# UNITED STATES PATENT AND TRADEMARK OFFICE

| APPLICATION NO. | FILING DATE | FIRST NAMED INVENTOR | ATTORNEY DOCKET NO. | CONFIRMATION NO. |
|-----------------|-------------|----------------------|---------------------|------------------|
| 10/714,232      | 11/14/2003  | Arne W. Ballantine   | PUG.0083C1US (792c) | 2447             |

## Office Action Summary

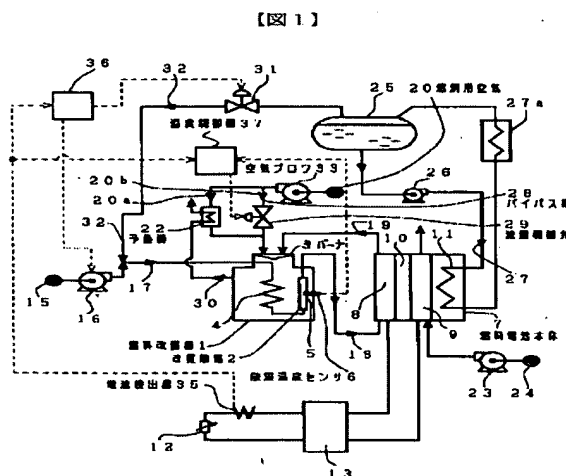
Figure 1 of the JP'365 illustrates a fuel cell power generating device (TITLE/ FIGURE 1) including a fuel cell 7 respective oxidant supply 24 and fuel supply 18 (FIGURE 1) which are provided for power generation; and a controller 36 for controlling fuel cell operating parameters (FIGURE 1). Particularly, controller 36 controls flow rate control valve 29 in response to conditions sensed by both temperature sensor 6 (heat sensor) and a current detector 35 (power demand sensor), and which is further adjusted according to a load current value of the fuel cell main body 7 (Abstract/Constitution).

Particularly, the JP'365 discloses that controller 36 controls flow rate control valve 29 in response to conditions sensed by both temperature sensor 6 (heat sensor) and a current detector 35 (power demand sensor), and which is further adjusted according to a load current value of the

fuel cell main body 7 (Abstract/Constitution). *Thus, control of at least fuel flow is based on the sensed temperature and the measured current and the load current value of the fuel cell. In this case, it is noted that the controller of the JP'365 is capable of performing the claimed function based on the particular sensed conditions. Thus, the controller of the JP'365 inherently controls the fuel cell system as instantly claimed in claims 52-55 and 57-58. In other words, the examiner is asserting inherency based on the structural and functional similarities between the disclosed controller and applicant's controller. In re Schreiber, 128 F.3d 1473, 44 USPQ2d 1429 (Fed. Cir. 1997).*
